# ***Safety Bulletin***

## ***TIVOLI MFG. LTD.***

**Bulletin No: ORSA002A**

**Ride Type: Orbiter (aka Typhoon, Predator)**

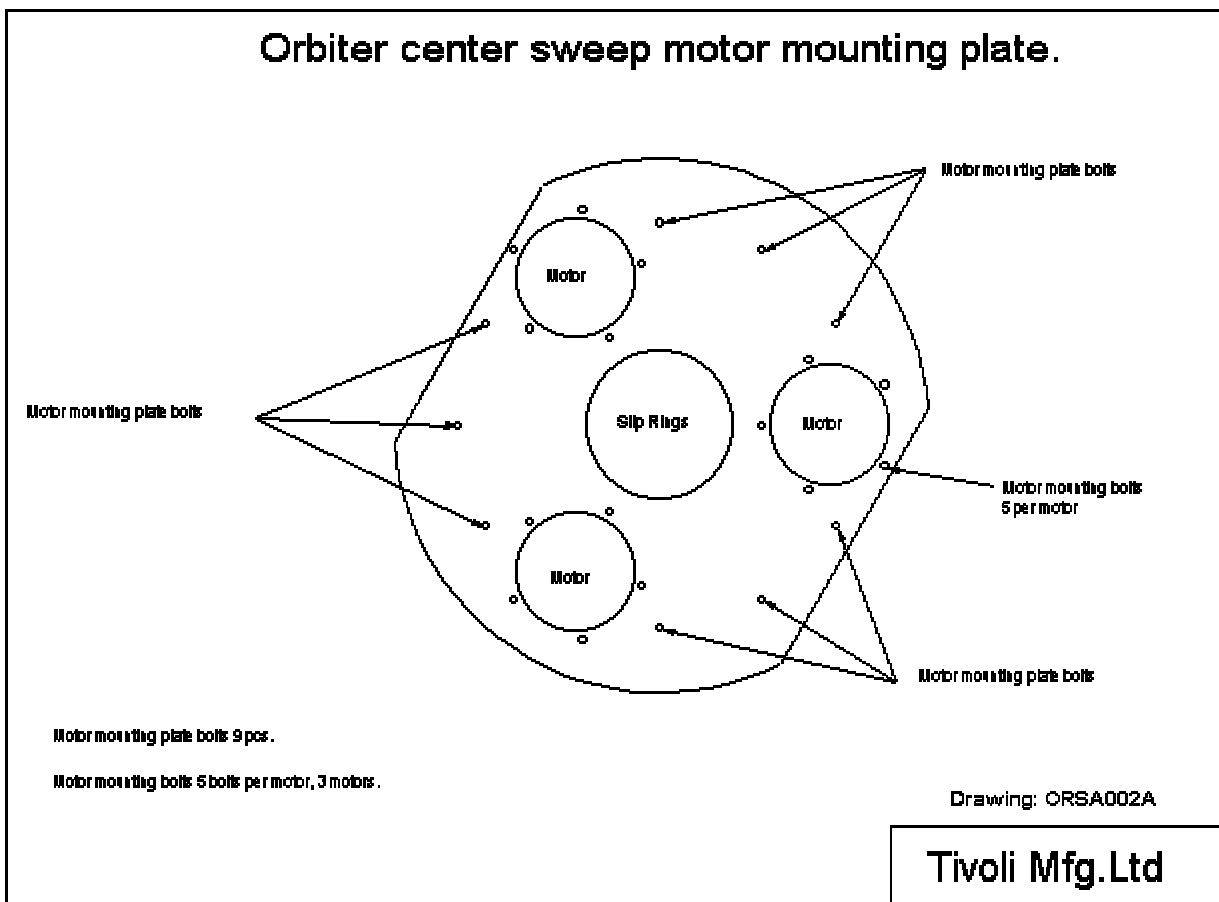
- **Replace all nine (9) bolts securing motors mounting plate to hub.**
  - 9 – 12mm x 45mm bolts spread equal distance around outside parameter of plate. See Attached drawing ORSA002A (See Attached)

#### **Bolt Specification for three motors and motor mounting plate.**

**Bolt:** Hex head, 12 mm x 45 mm x 1.75, grade 8.8, partial thread, black finish. Ref: DIN 931 / ISO4014

**Washers:** 12 mm, flat hardened washers, 13 mm ID, 24 mm OD, 3 mm thick. C45. Ref: DIN 6916

**Tightening Torque Requirements:** Tighten bolts to 65 ft-lbs.
